GLEN EIRA CITY COUNCIL

Submission to the Activity Centres Program Stage 2

Map 11 - Glen Huntly Catchments

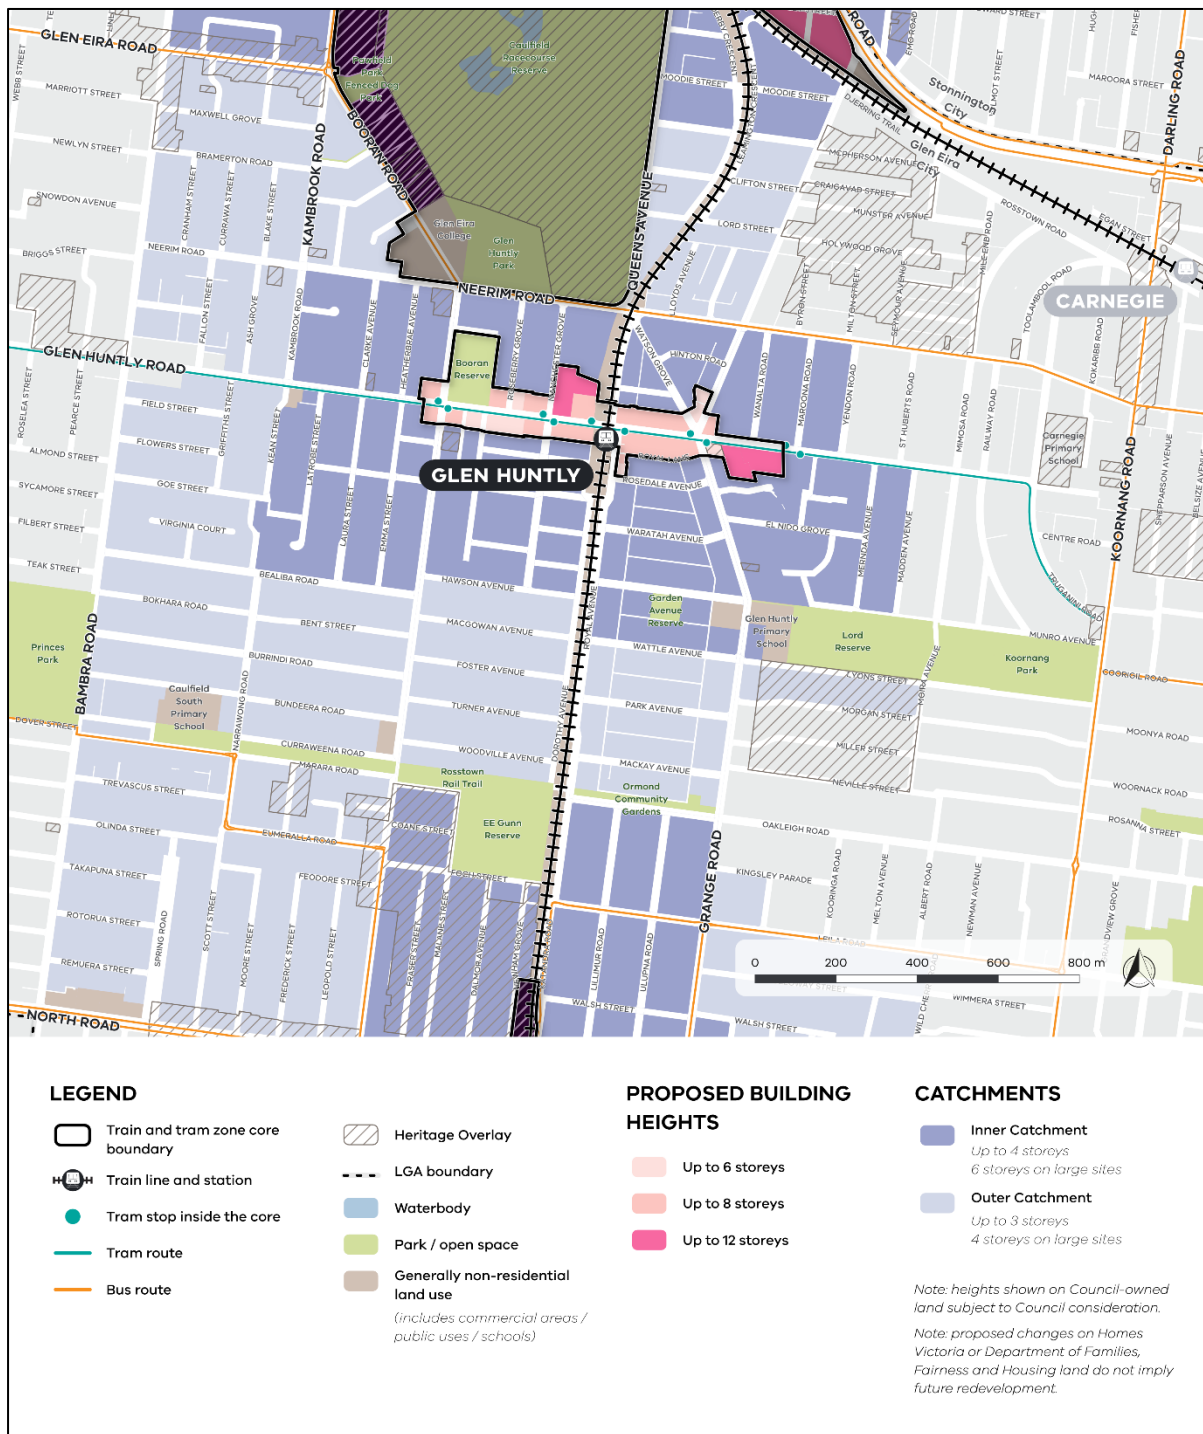
The proposed outer catchment appears to extend further west than it does east, however, land to the east is already proposed to be within the catchment of the Carnegie Activity Centre Plan which formed part of Stage 1 of the AC Program. This creates a continuous inner and outer catchment from Glen Huntly all the way to Oakleigh. There is also a continuous catchment from Caulfield down to Bentleigh. This will result in significant change over time to these residential

Council also questions whether fragmentation has been considered. The proposed inner catchment to the south-east of the station is predominately comprised of smaller units and apartments. Such conditions significantly reduce the likelihood of redevelopment.

With the potential for 6-storey buildings to be developed north of Booran Reserve, Gordon Avenue Reserve and Lord Reserve, we raise concerns about overshadowing to these open spaces. Council questions how this will be managed through planning controls, such as the HCTZ or deemed to comply standards.

Map 12 - Ormond Catchments

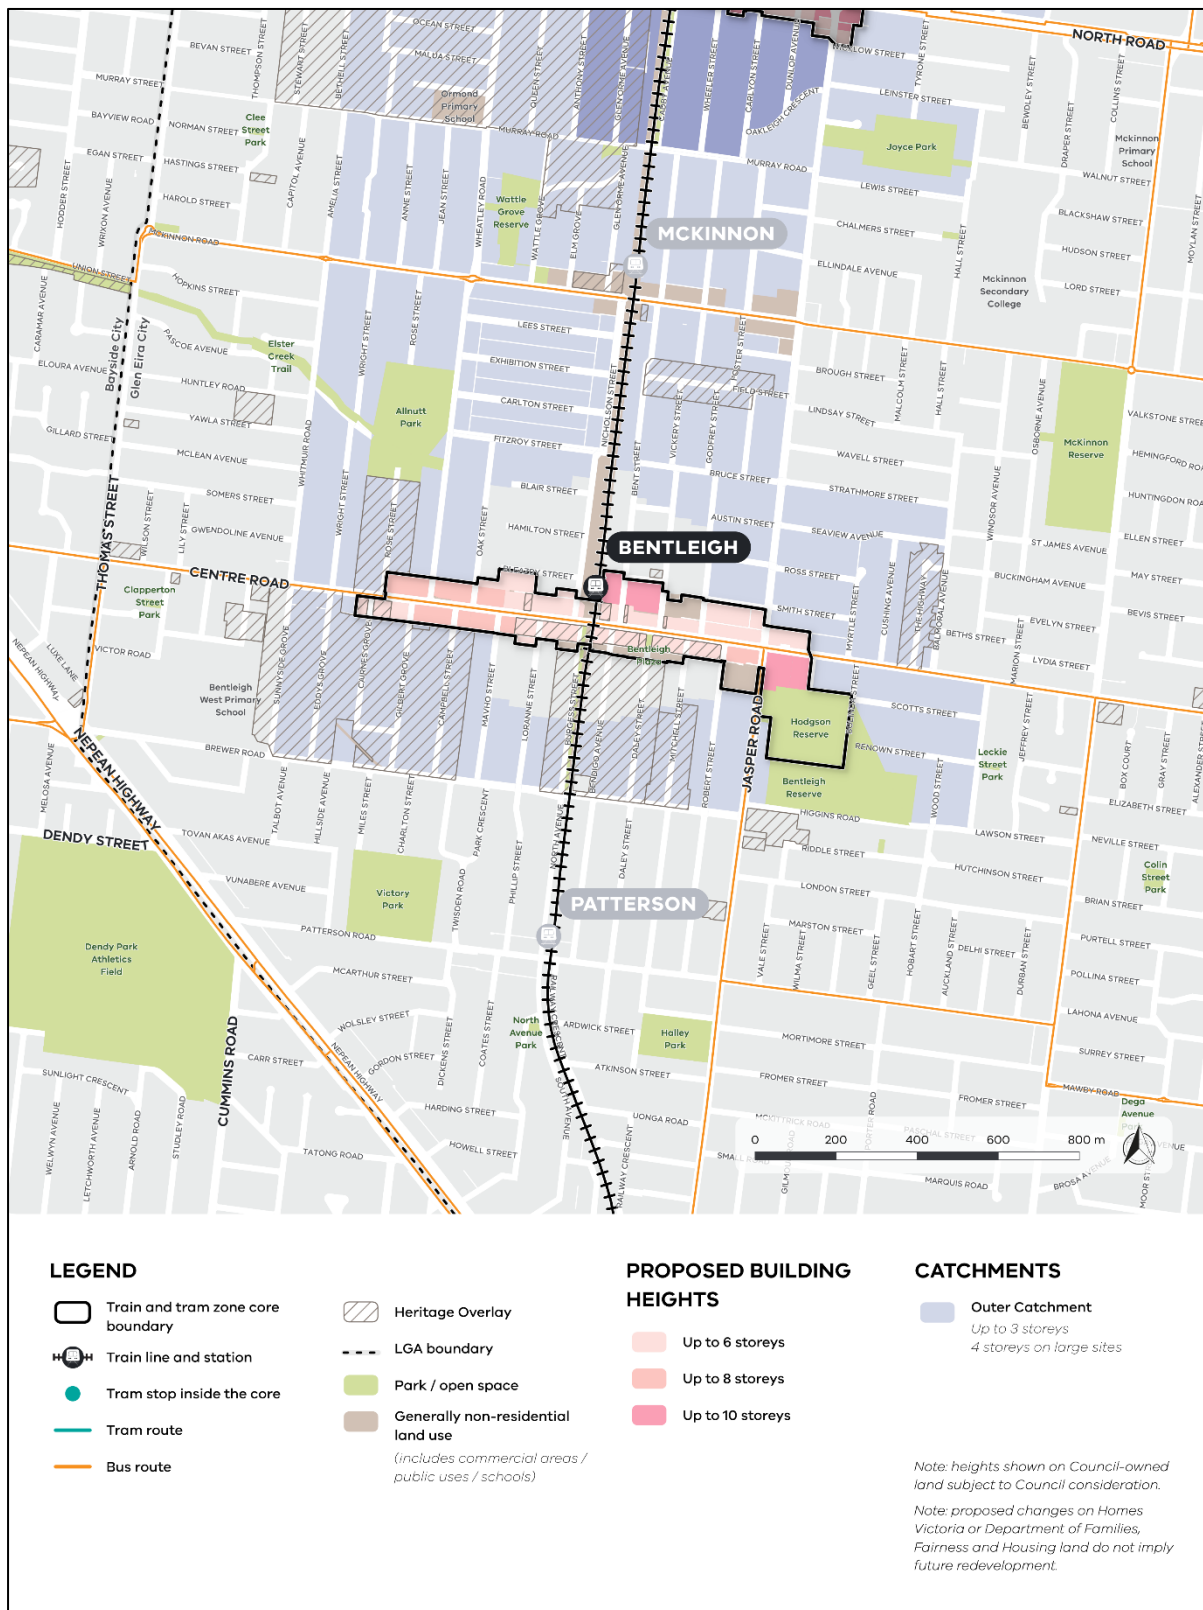
The application of the catchments around Ormond appears to be inconsistent. Council questions why the catchment extends further west on the north side of North Road than the south (west of Scott Street). This is extensive, for example a resident in Trevascus Street, Caulfield South (located in outer catchment northwest of core) would have to walk over 1.3 kilometres to the edge of the shops, or 1.7 kilometres to the station.

Furthermore, the block south of Murray Road and west of Wheatley Road, which includes land up to Amelia Street in McKinnon is also considered unnecessary and should be removed from the catchment due to the distance from the core. The inclusion of McKinnon in the Ormond catchment is not justified, nor was this communicated adequately to residents. Again, there appears to be a bias towards extending the catchments to the west which is not clearly backed by a clear methodology other than using conveniently located north/south roads to define the boundary on a map.

It is also questioned why the catchment extends further east on the north side of North Road than it does on the south side. Overall, Council submits that the same principles should apply when determining catchment boundaries.

Map 14 - Elsterwick Catchments

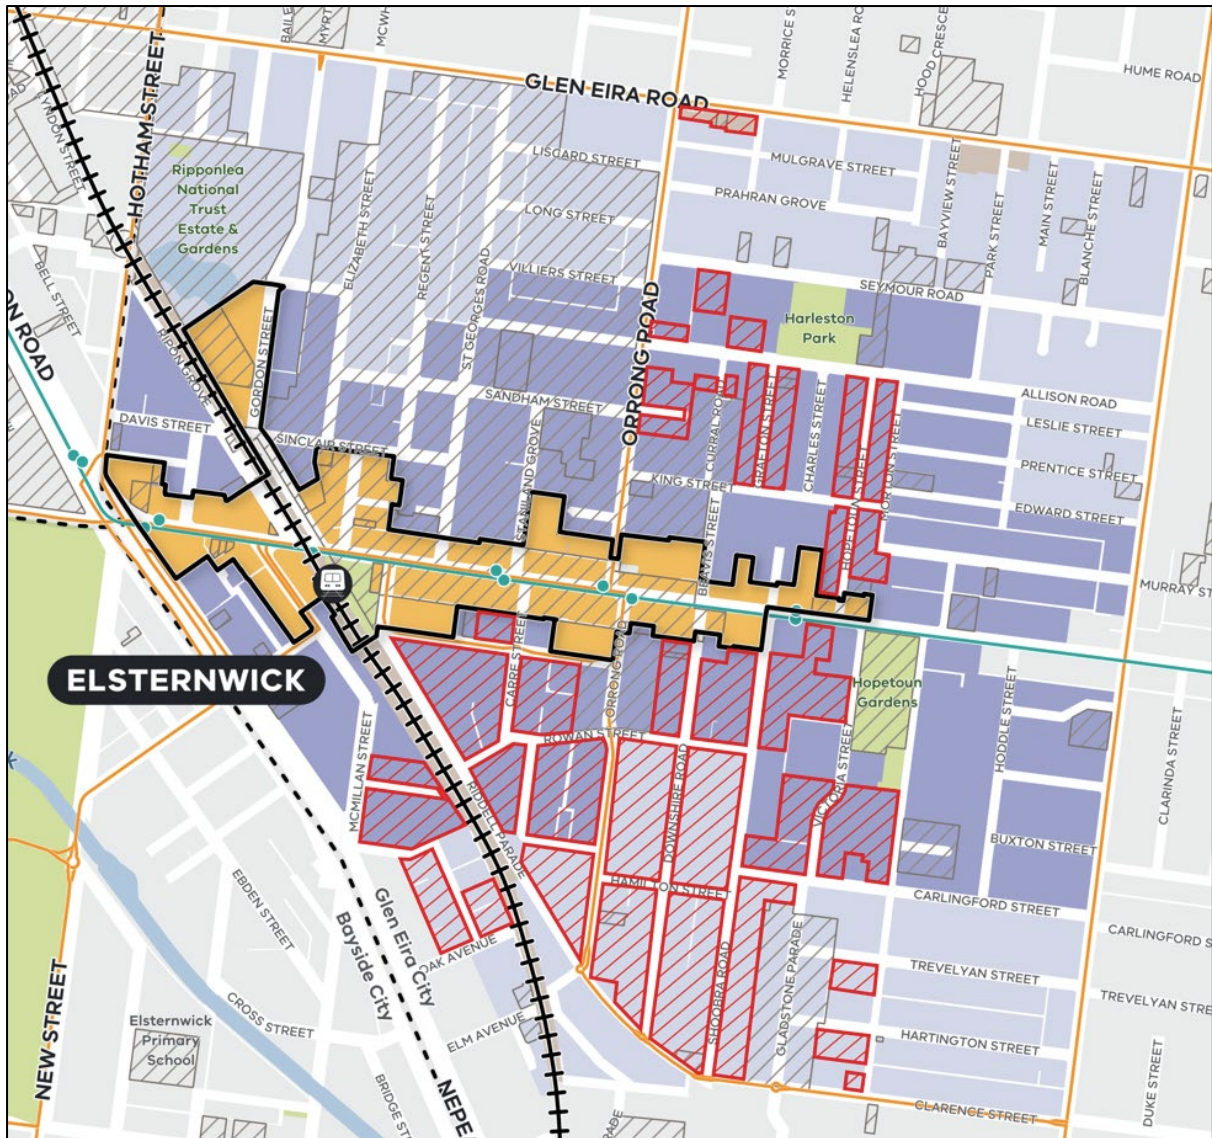
Nearly half of the proposed catchments in Elsterwick are affected by an existing or proposed heritage overlay. We submit that these existing and proposed heritage properties should not be included in the activity centre catchment and upzoned as a result of this. We also strongly oppose the inclusion of the Australian National Heritage listed Rippon Lea Estate within the outer catchment. Should the Minister disagree with this reasonable position, then at the very

least, we submit that the existing and proposed heritage precincts should not be split between the inner and outer catchment as this would affect the significance of these heritage areas. We strongly oppose the inclusion of any heritage within the inner catchments. The below map shows proposed heritage in red that was not depicted on DTP's map:

Map 15 - DTP map of Elsternwick with proposed heritage added in red

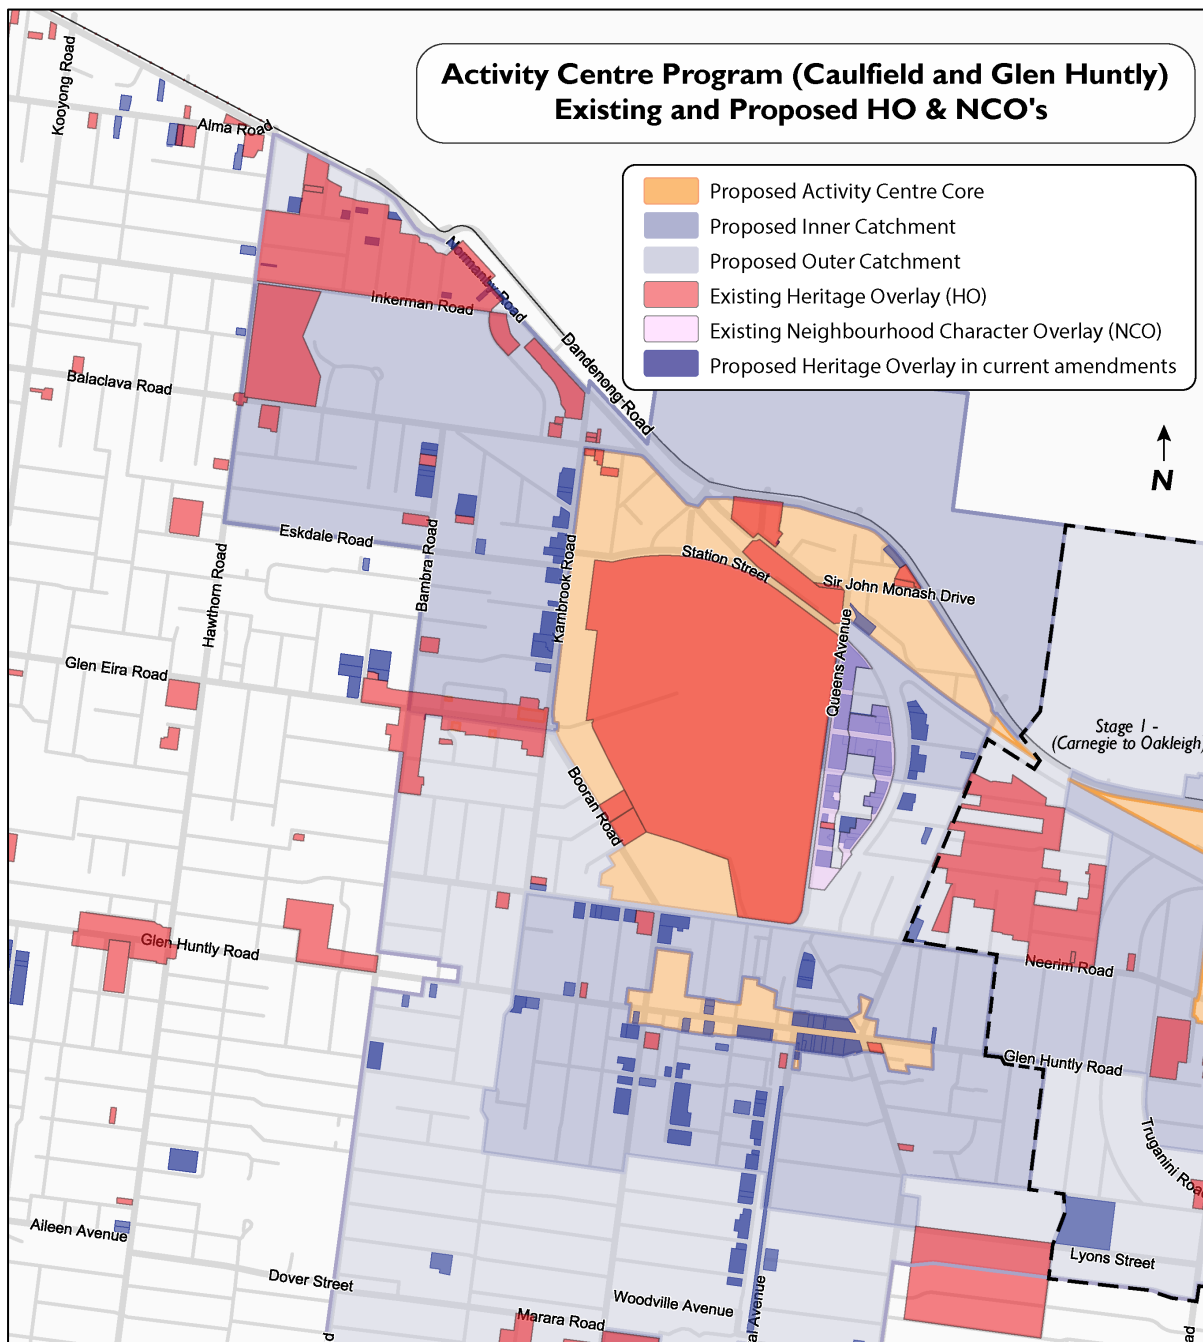
Furthermore, the upzoning of land via the HCTZ is inconsistent with what is proposed under Council's Planning Scheme Amendment C257glen (Elsternwick Heritage). C257glen, consistent with Planning Practice Notes 90 and 91, proposes to downzone heritage areas in Elsternwick to a 2-Storey Neighbourhood Residential Zone while allowing for intensive development west of the railway line. This proposal allowed for the activity centre to grow whilst protecting the valued heritage areas surrounding the core. Council queries whether the explanatory reports and justification for amendment C257glen zoning have been considered by the activity centre program team? It is noted that residential land around the Elsternwick commercial strip was placed in a 4-storey Residential Growth Zone at a time when sweeping zones were implemented by desktop review at state government level and without proper consideration of the heritage context. Council's proposed amendment sought to rectify this zoning oversight.

The inner catchment appears to extend quite far east, past Hopetoun Gardens, particularly when the train station is located towards the western end of the centre. Council questions the inconsistency of this. It is noted that the catchments do not extend west across Hotham Street and Nepean Highway (Port Phillip and Bayside councils). Many of these properties are much closer to the shops and train station than land to the east. Furthermore, DTP's map includes Elsternwick Park as one of the three "places you love spending time in" yet this is also outside of the catchment. If Nepean Highway was considered a significant barrier for walkability, why wasn't the same principle applied to Caulfield with land across Dandenong Road? We question whether municipal boundaries have influenced the selection of boundaries. Council submits that these inconsistencies should be addressed.

With the potential for 6-storey buildings to be developed north of Hopetoun Gardens and Harleston Park, we raise concerns about overshadowing to these open spaces. Council questions how this will be managed through planning controls, such as the HCTZ or deemed to comply standards. The extent of the inner and outer catchments to the west of the core can be reduced on the basis that areas to the west, beyond Nepean Hwy and Hotham St can be included.
